### ADDENDUM 1

CSP 22-92

## Cavazos Elementary School Heating & Air Condition (HVAC) Improvements Funded through the Elementary & Secondary Emergency Relief (ESSER) Funds May 31, 2022

## Addendum

**DATE:** 05/05/2022  
**DRAWN BY:** DBR  
**CHECKED BY:** DBR  
**PROJECT NUMBER:** 218007.005  
**SHEET TITLE:** LEVEL 1 ELECTRICAL POWER PLAN - DEMOLITION - AREA B  
**SHEET NUMBER:** EPD2.12B

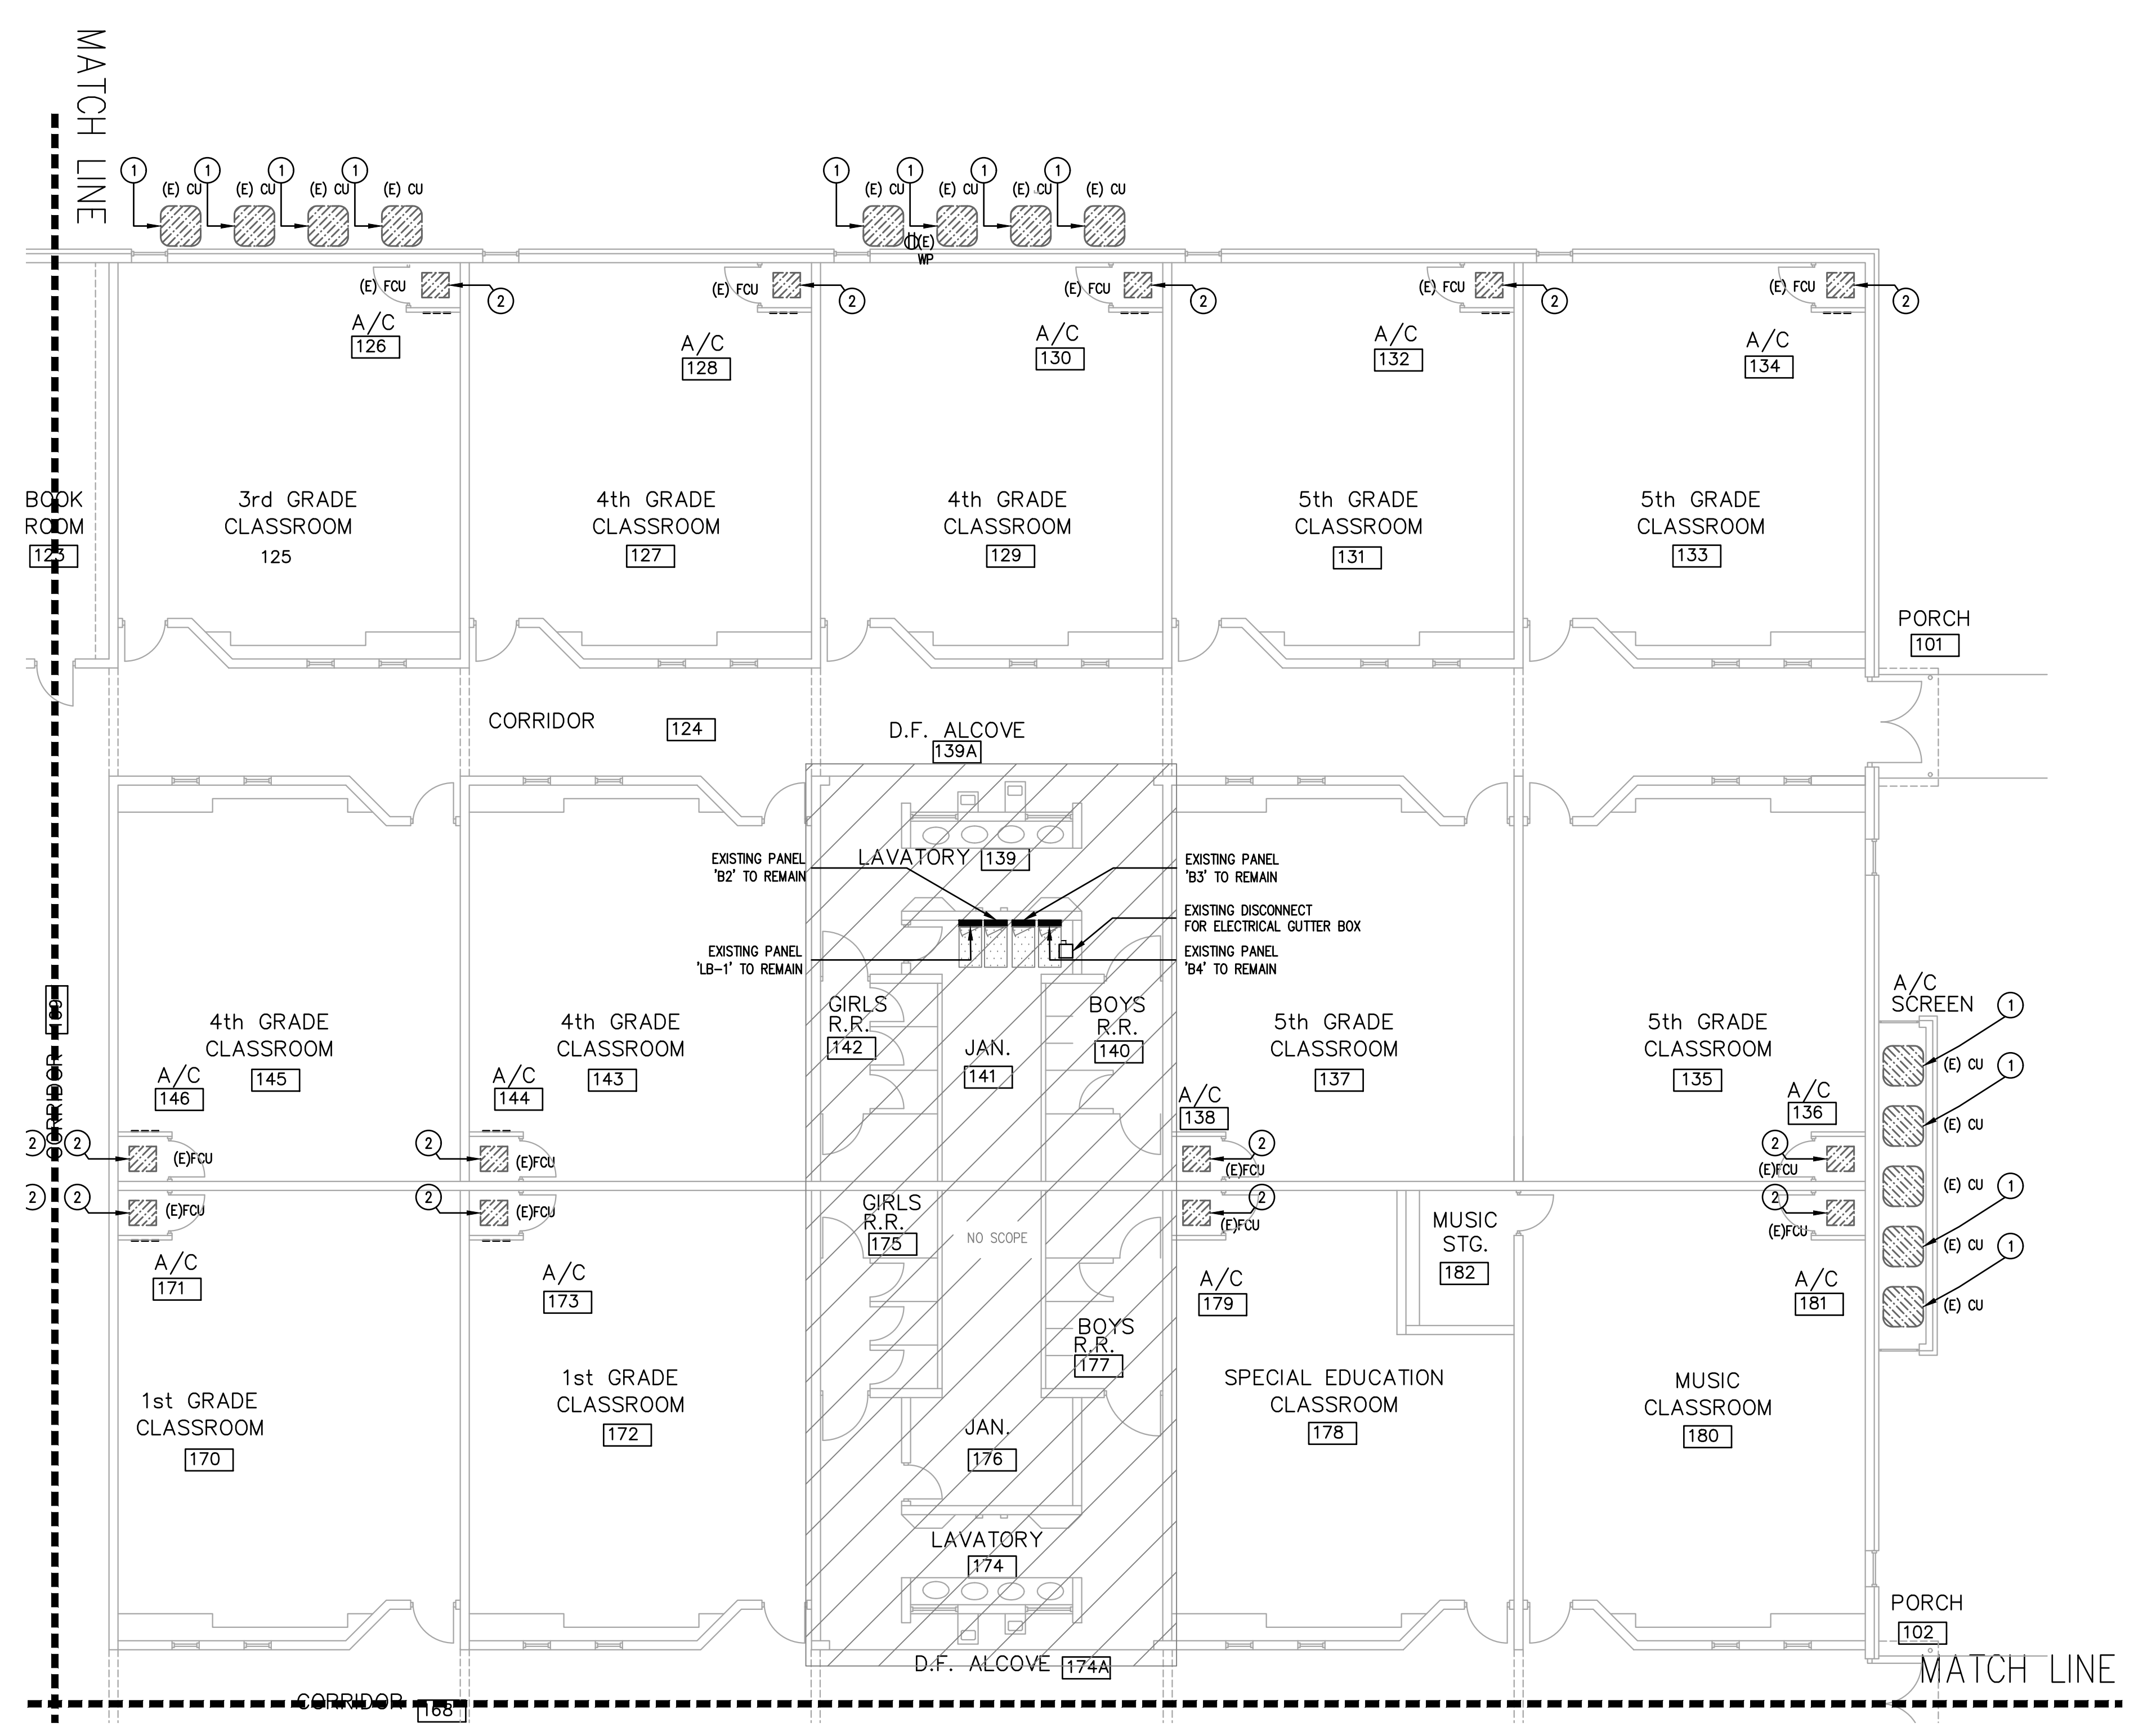
**Item 13 EPD2.12B – LEVEL 1 ELECTRICAL POWER PLAN – DEMOLITION – AREA B**

- A. Revised keyed note 2.

<b>DATE:</b>	05/05/2022
<b>DRAWN BY:</b>	DBR
<b>CHECKED BY:</b>	DBR
<b>PROJECT NUMBER:</b>	218007.005
<b>SHEET TITLE:</b>	LEVEL 1 ELECTRICAL POWER PLAN - DEMOLITION - AREA C
<b>SHEET NUMBER:</b>

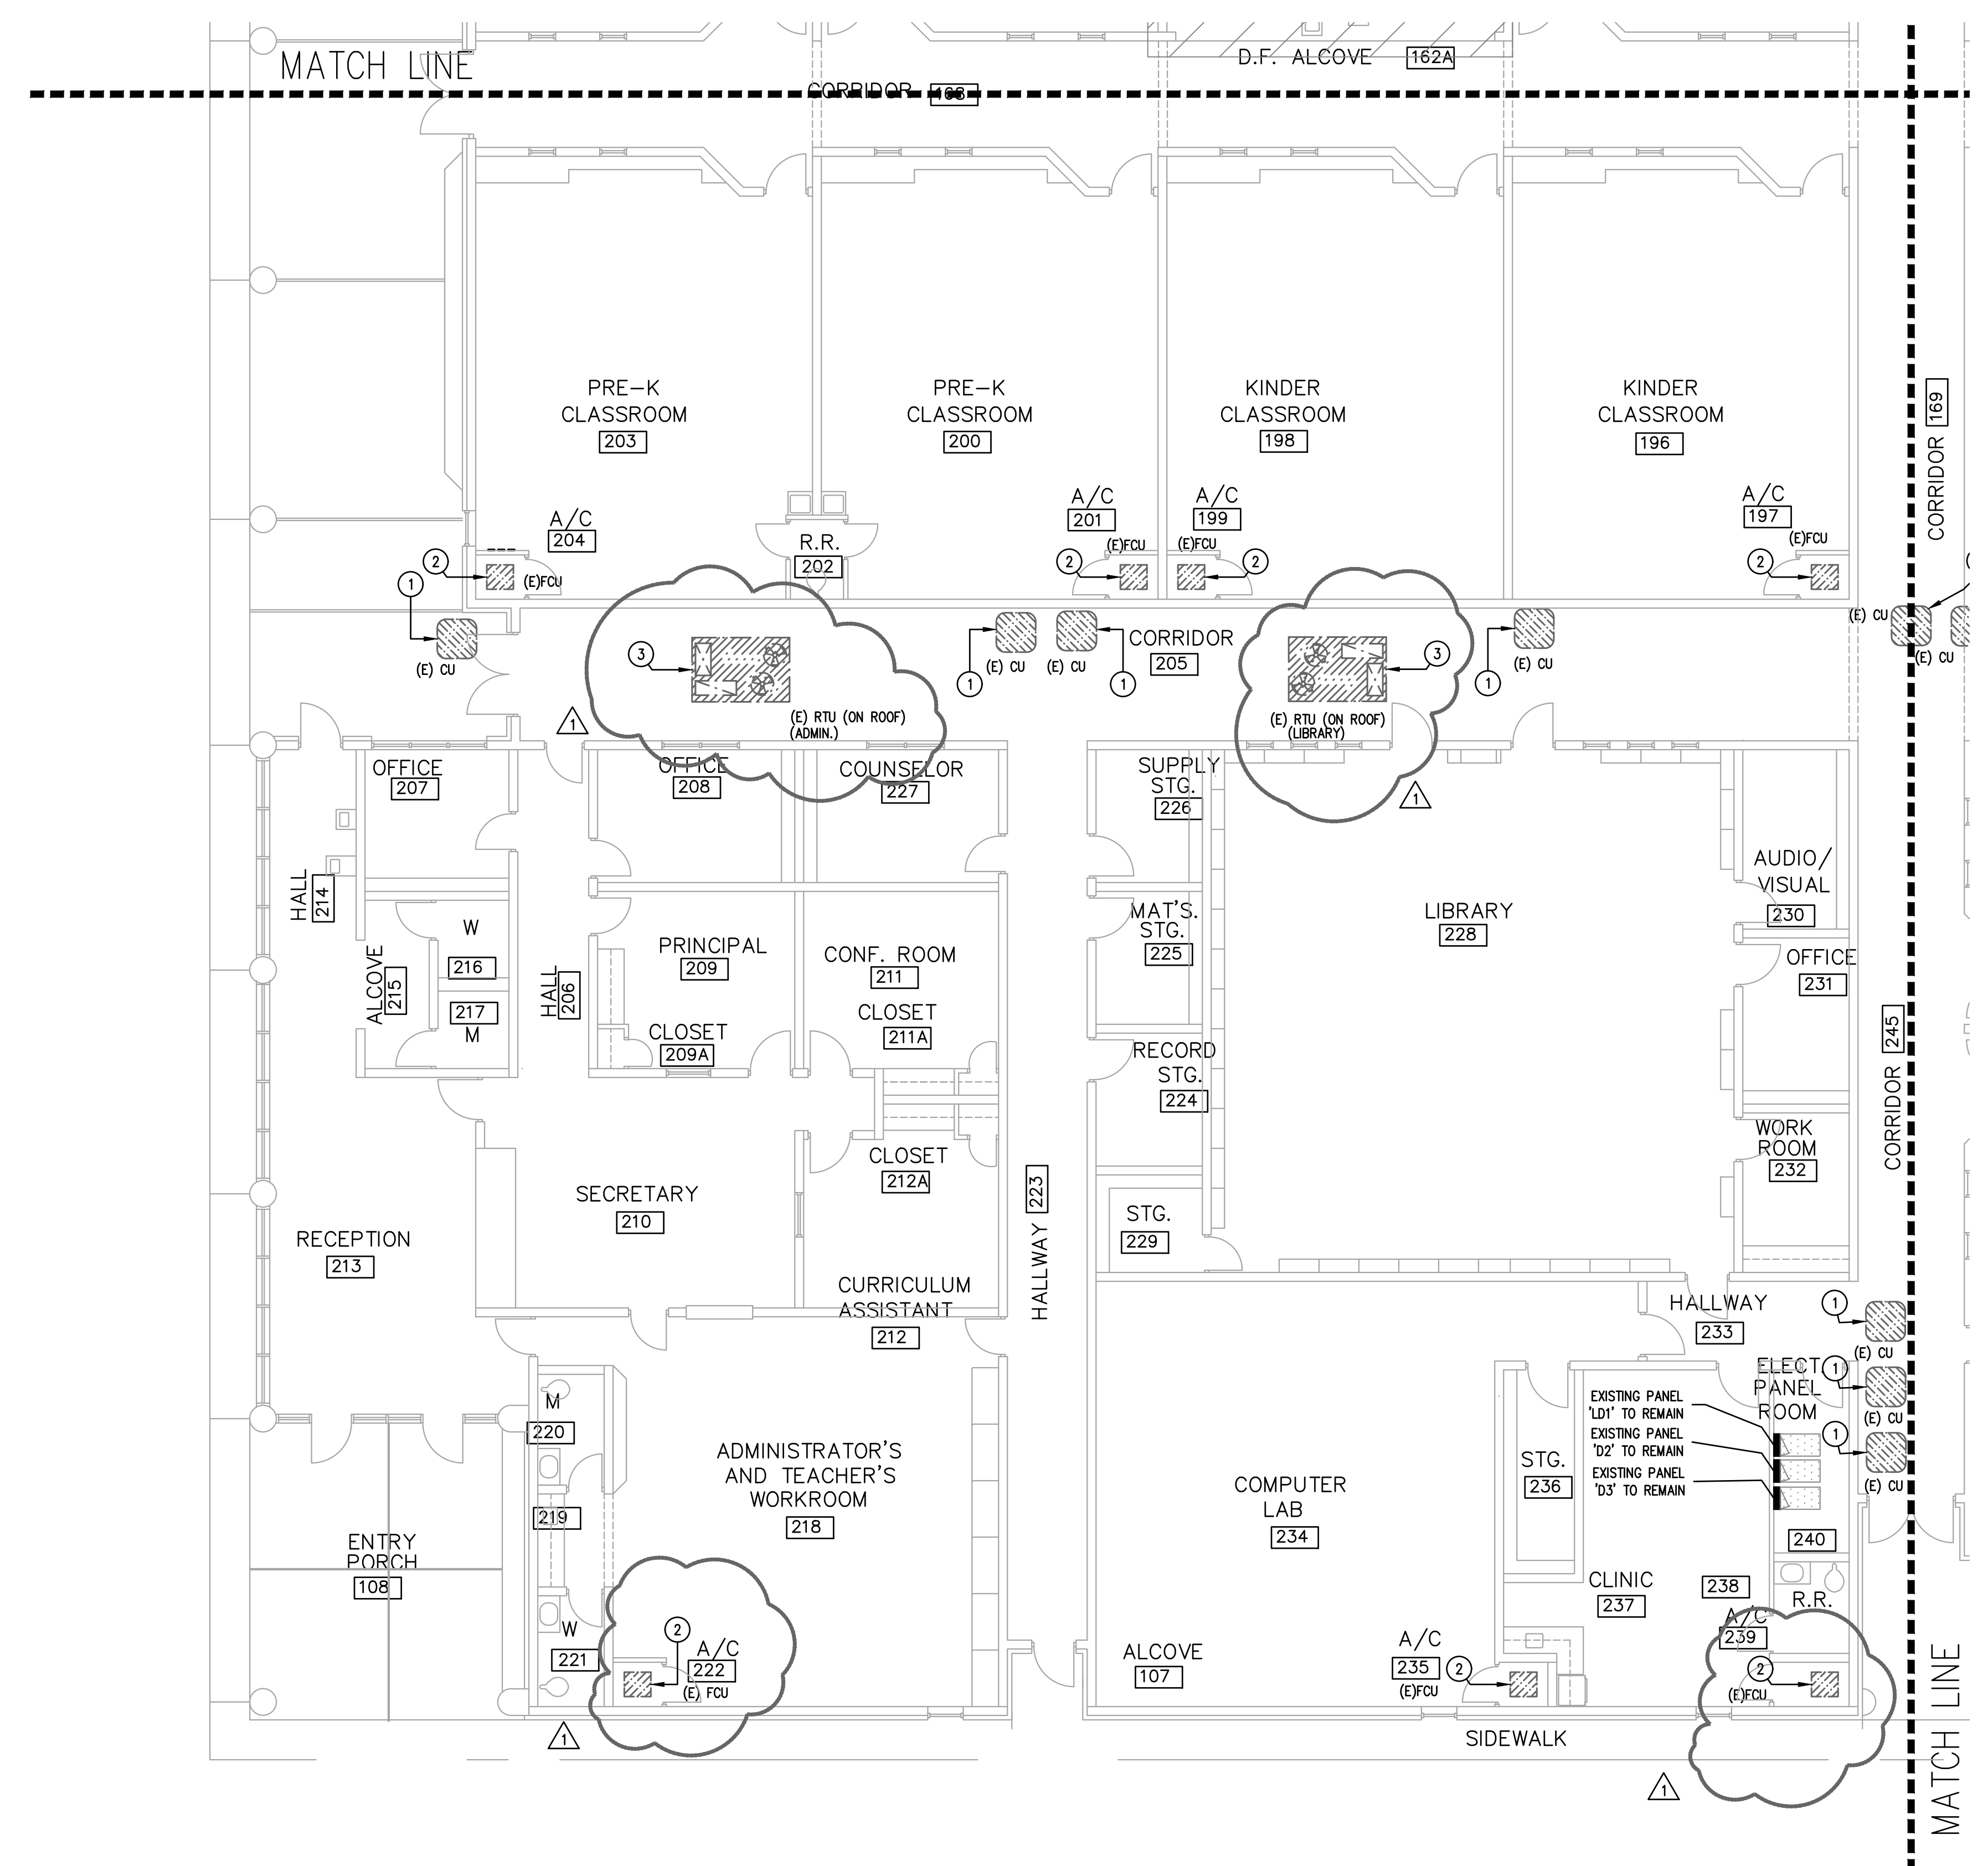
**Item 14 EPD2.13C – LEVEL 1 ELECTRICAL POWER PLAN – DEMOLITION – AREA C**

- A. Revised keyed note 2.
- B. Added keyed note 3.

**EPD2.14D**

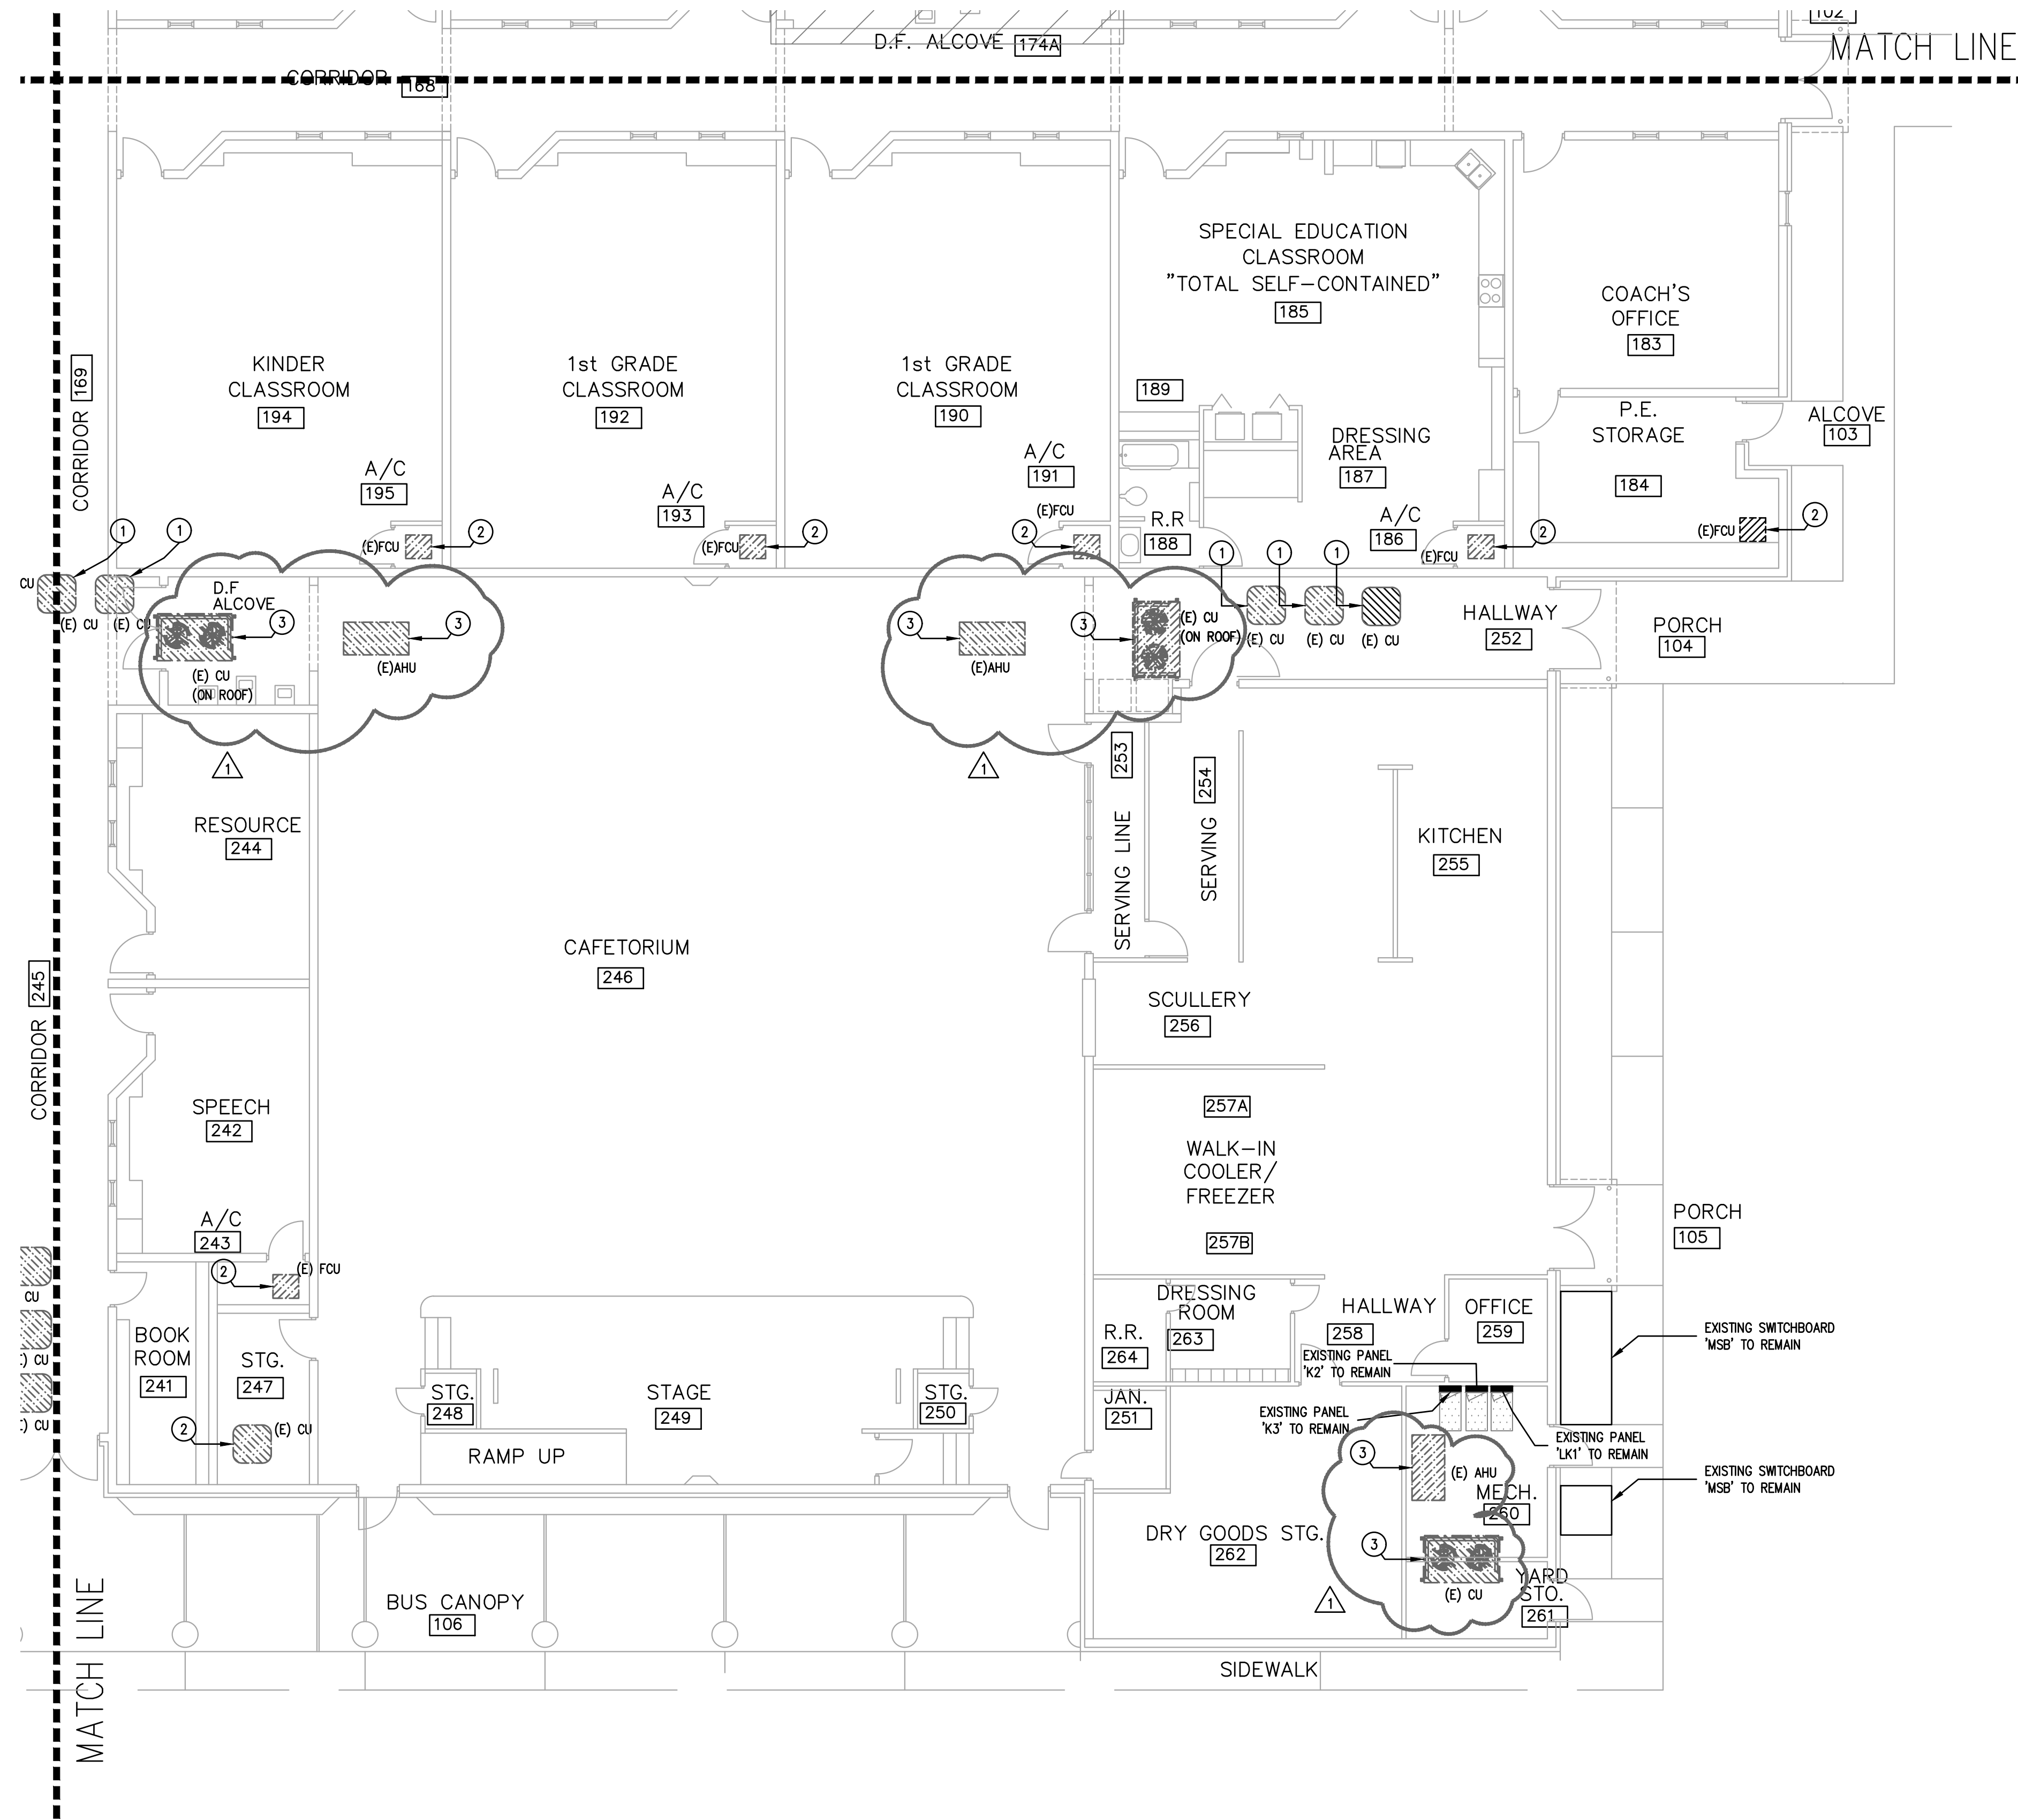
**Item 15 EPD2.14D – LEVEL 1 ELECTRICAL POWER PLAN – DEMOLITION – AREA D**

- A. Revised keyed note 2.
- B. Added keyed note 3.
